**Boeing Airplane Services**

**Regulatory Docket  
No. FAA-2000-8508**

**PARTIAL GRANT OF EXEMPTION**

ANM-01-093-E The requested exemption, if granted, would permit relief from the requirements of these regulations for the Boeing Model 757-200 series

**757 Special Freighter  
Emergency Exit Arrangement**

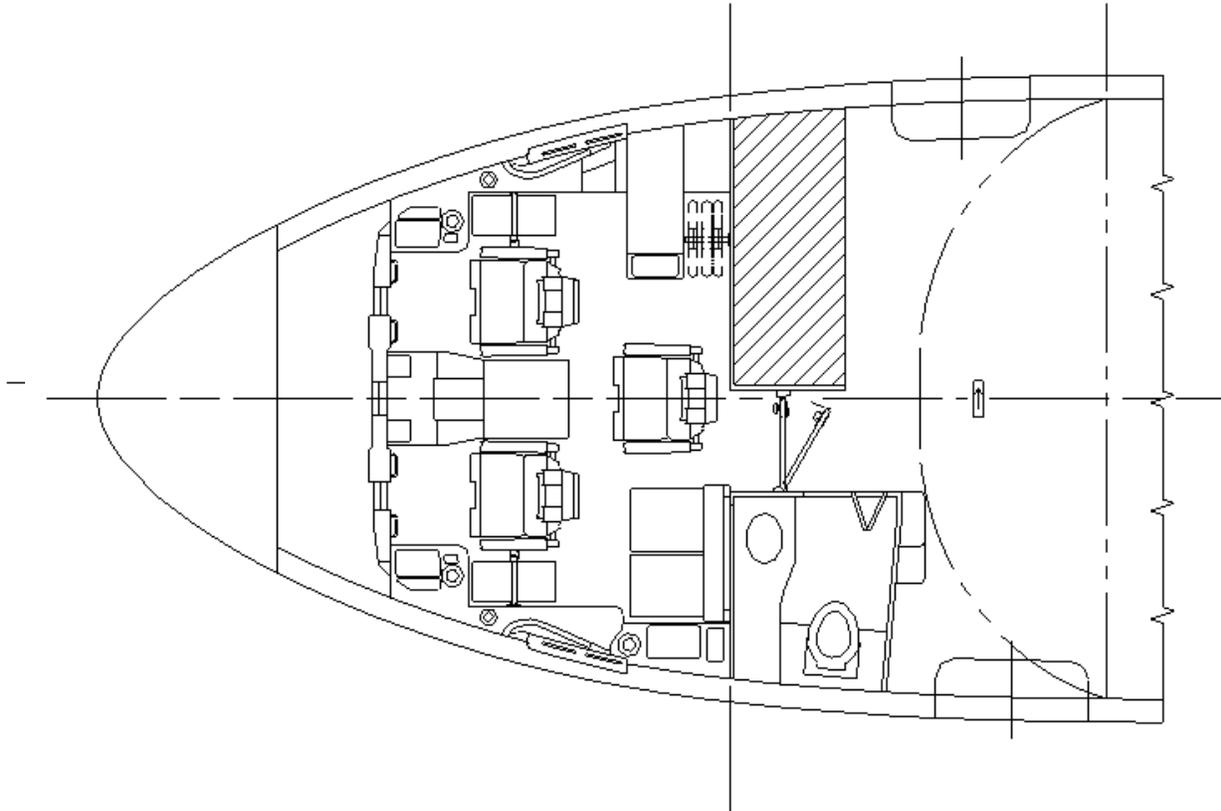
*“The Special Freighter conversion includes deactivation of all passenger doors except Doors 1 Left and 1 Right. Blockage of Door 1 Left by the distended cargo barrier net and contained cargo will occur in event of a 9g emergency landing situation.*

*“Door 1 Left will therefore be modified to be used as a service door only, the slide will be removed, and the interior door liner placarded to indicate slide removal. The Door 1 Right slide will be replaced with inertia reel descent devices, and the bustle with a flat liner. This door will serve as an exit in all landing cases. Interior and exterior markings / signage that indicate emergency exit use of the Right Hand door will be retained or installed as necessary.*

*"None of the three available exits will be relocated, and are all above the waterline of the airplane in a ditching situation.*

*"It is Boeing's position that the combined presence of Door 1 Right and the two window exits, all equipped with assist means appropriate to their use, provides a level of safety for this airplane and its intended use that is equivalent to that provided for other airplanes and/or uses meeting the provisions of 25.807(d)(1) and (e)(1).*

*"The Special Freighter will similarly be equipped with inertia descent devices as assist means at Door 1 Right, which is a Type I door. Inertia reel descent devices at exit doors have been shown to be as safe and effective as automatically erected slides for evacuating small numbers of occupants. Demonstrations and actual emergencies in which slides have been used to rapidly evacuate airplanes typically have resulted in injuries to the evacuees. The use of reels with a small number of occupants has the potential to mitigate injury during evacuation. Also, the use of reels, or reels plus harnesses, is a simple, intuitively obvious process, is not strenuous, and does not require specific positioning or movements by the evacuees.*

*"The left-hand cockpit window will be modified to be externally operable, and the ropes/lanyards at both windows retained. The proximity of the ropes installed at the flight deck windows to the flight crew, who will be able to insure proper use by all occupants, provides a significant offsetting consideration in lieu of automatically erected means.*

The intent of § 25.783(h) is to ensure that the door through which people enter an airplane is also useable as an emergency exit and meets the requirements of § 25.807 through § 25.813. The right-hand door will be used as the entry door for the special freighters and will comply with all of the requirements for an emergency exit, except for the sections of the regulations that are covered by this exemption.

The emergency exit provided on the left side of the airplane -- the No. 2 left flight deck window -- does not meet the minimum size requirements for a Type IV exit as required by § 25.807(d)(1). The Boeing Company has previously demonstrated the utility of the No. 2 right flight deck window, and the usability of that exit opening with the evacuation means provided for a maximum occupancy of seven people on the flight deck of the Model 757-200PF. The No. 2 left flight deck window on the petitioner's airplane is a mirror image of the No. 2 right flight deck window that was demonstrated for utility and usability. Also, the three non-crew members of the airplane will have a higher level of training than a typical passenger, and will be more physically capable of evacuating the airplane using the reduced exit opening size provided on the left side of the airplane than normal passengers.

The FAA recognizes that supernumerary occupants, as opposed to passengers, may be selected and trained appropriately in the use of escape ropes and inertia reels and harnesses. For such incapacitated occupants, the FAA considers that inertia reels and harnesses offer an acceptable escape means of emergency egress. The FAA considers that the petitioner’s proposed installation of inertia reels and harnesses at the entry door and escape rope at the No. 2 left flight deck window provides an adequate level of safety for the petitioner’s airplane configuration.
